**Urling Planning Associates
2366 West Hills Drive
Longview WA 98632**

Re: Appeal of Clear Lake Preliminary Plat Planning Commission Approval

Our geotechnical recommendations are not intended to direct the contractor's procedures, methods, schedule or management of the work site. The contractor is solely responsible for job site safety and for managing construction operations to minimize risks to on-site personnel and adjacent properties.

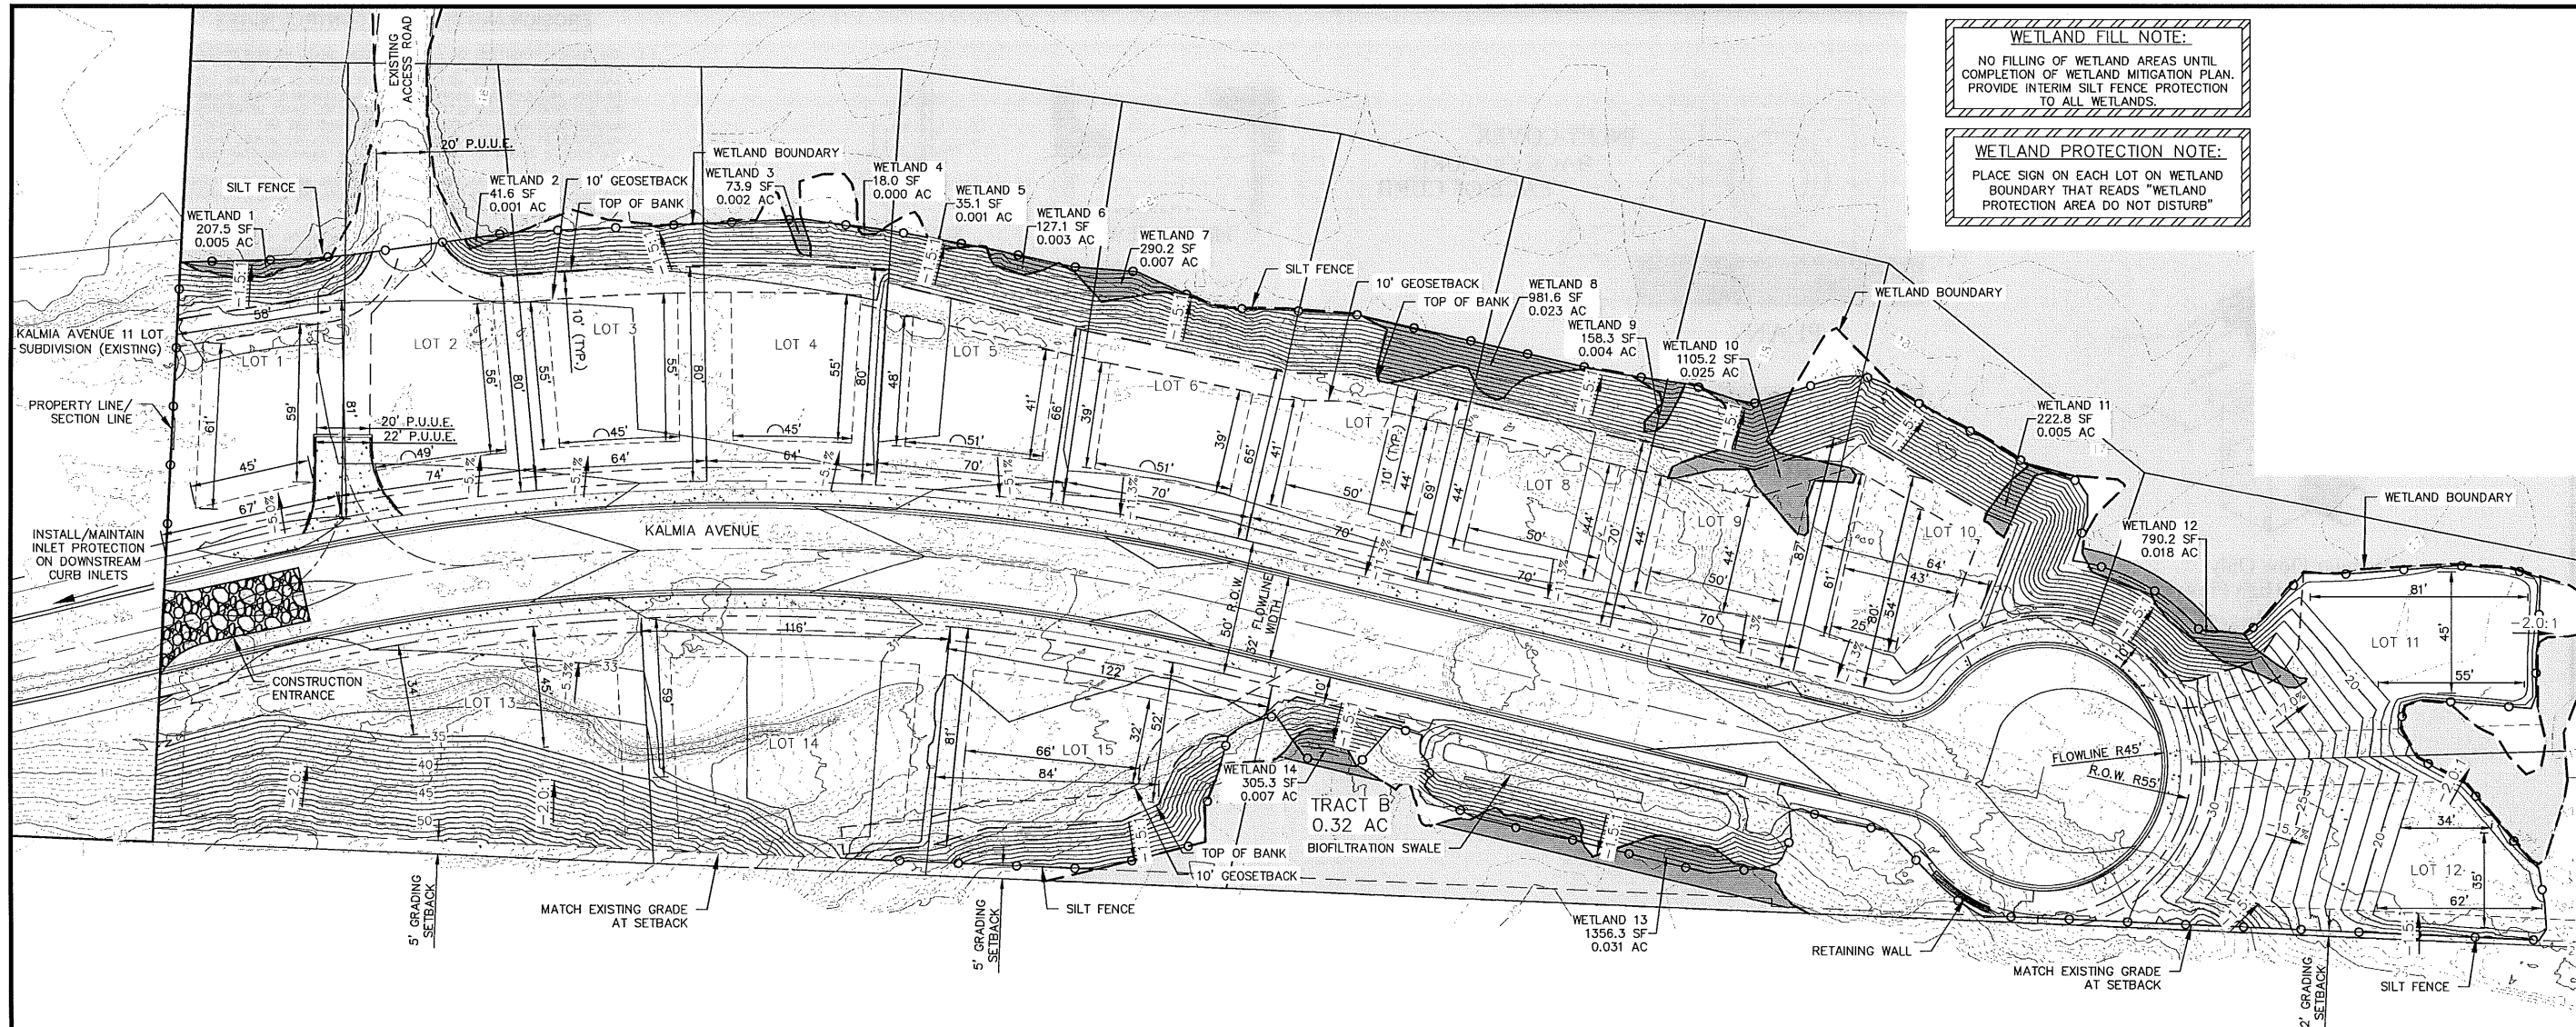
Also Note: The plan (sheet 3 of 4) shows the typical section for Kalmia Avenue being in a "Tract" which implies private ownership. I believe all of the documents state that this will be a public street. This label should be removed or clarified.
